WOLF CREEK

Subject: Docket No. 50-482: Revision to Technical Specifications
3/4.8.2.1, 3/4.8.2.2, 3/4.8.3.1 and 3/4.8.3.2 - Electrical
Power Systems - D.C. Sources and Onsite Power Distribution

ATTACHMENT I
SAFETY EVALUATION

FIGURE 1
WOLF CREEK
SAFETY-RELATED
125VDC SYSTEM
(Simplified)

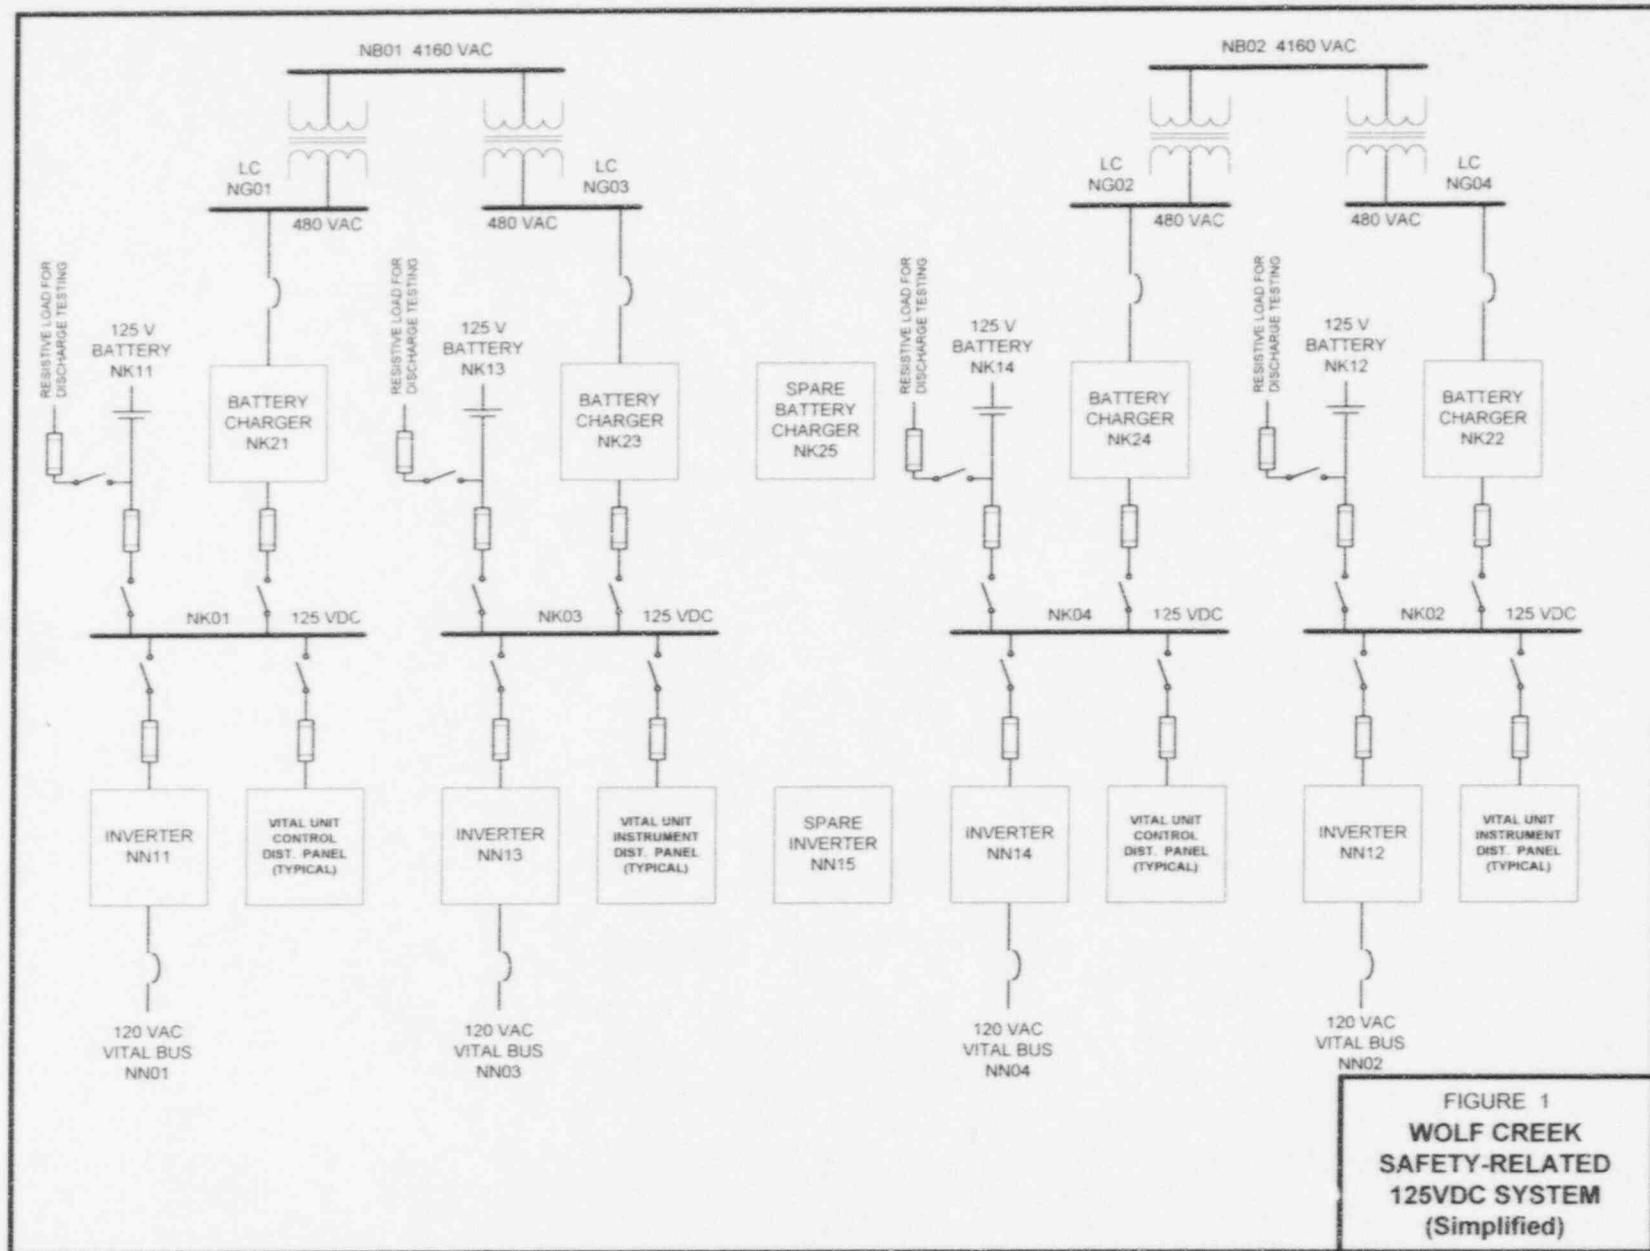
Figure 1 is a simplified drawing of the safety-related 125-volt D.C. system at Wolf Creek Generating Station. This figure shows the connections from the two 4160-volt A.C. Emergency Busses (NB01 and NB02) through the four 480-volt A.C. Emergency Busses (NG01/NG03, NG02/NG04). The NG busses supply power to the four full capacity chargers (NK21/NK23, NK22/NK24). Each charger supplies a Class 1E 125-volt D.C. bus (NK01, NK03, NK02, and NK04) and an associated 125-volt battery bank (NK11, NK13, NK12, or NK14).

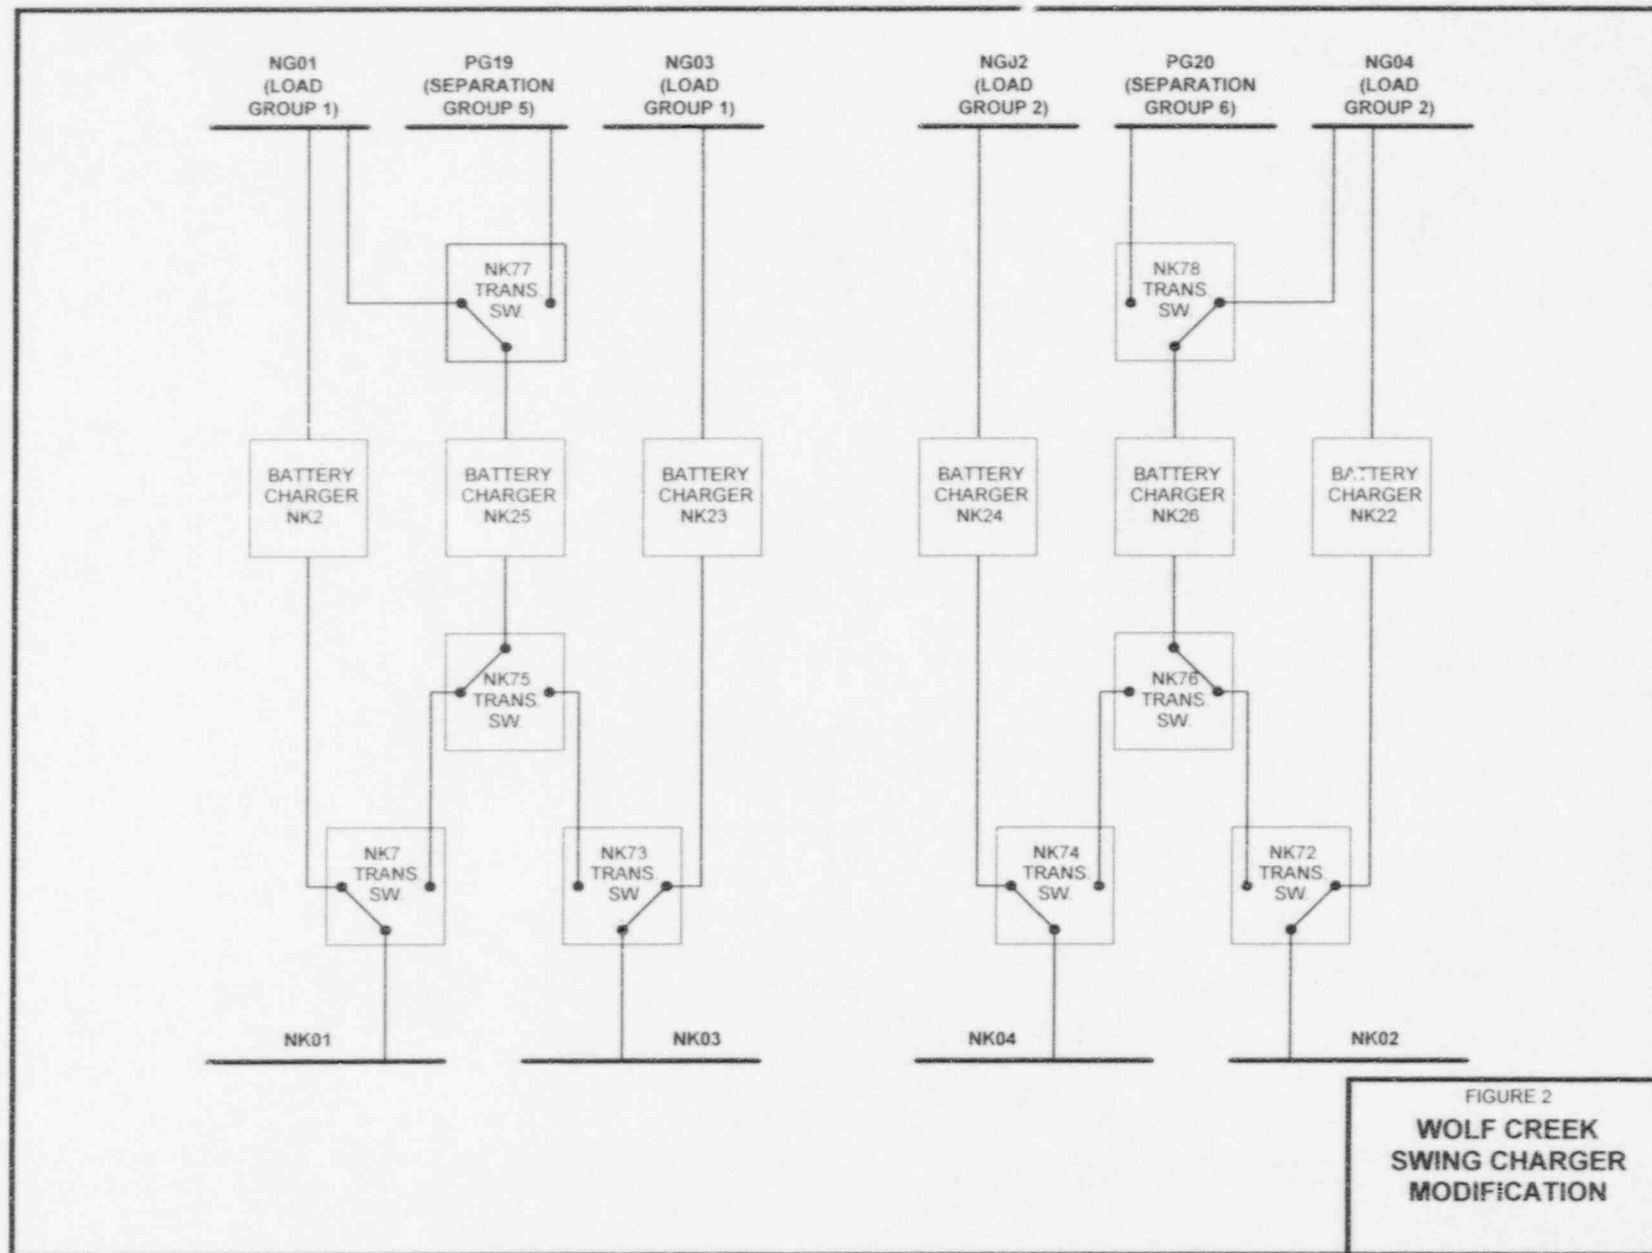
The modification to be implemented during the eighth refueling outage will provide permanently installed spare chargers for the 125-volt D.C. system (Reference Figure 2).

The current spare battery charger will be permanently installed as a spare swing charger for the 125-volt D.C. Busses NK01 and NK03. A new charger will be installed as a spare swing charger for 125-volt D.C. Busses NK02 and NK04. Each Class 1E D.C. power subsystem will then consist of one 125-volt battery, one primary battery charger, one inverter, distribution switchboards, a shared swing battery charger, and swing battery charger transfer switches. The battery chargers for D.C. subsystems 1 and 3 will be supplied 480-volt A.C. power from different Class 1E busses of Load Group 1 while their shared swing battery charger will be supplied 480-volt A.C. power from either a Class 1E bus of Load Group 1 or a Non-class 1E bus from Separation Group 5. Similarly, the battery chargers for D.C. subsystems 2 and 4 will be supplied 480-volt A.C. power from different Class 1E busses of Load Group 2 while their shared swing battery charger will be supplied 480-volt A.C. power from either a Class 1E bus of Load Group 2 or a Non-class 1E bus from Separation group 6.

Two swing battery charger subsystems will be provided for the Class 1E D.C. power subsystems. One for use with Class 1E D.C. subsystems 1 and 3 and the other for use with Class 1E D.C. subsystems 2 and 4, permanently connected to their respective Class 1E D.C. power subsystems via manually controlled, electrically operated, transfer switches. In the event of a failure of a primary battery charger, the respective swing battery charger can be quickly aligned to provide power to the affected D.C. power subsystem. Therefore, the malfunctioning equipment may be repaired without imposing long-term disruption of the system. Once the swing battery charger is aligned to a given D.C. power subsystem all of the required annunciated trouble conditions are monitored on the swing charger and an annunciator window on the main control boards is lit to alert the control room staff that a swing charger is in use.
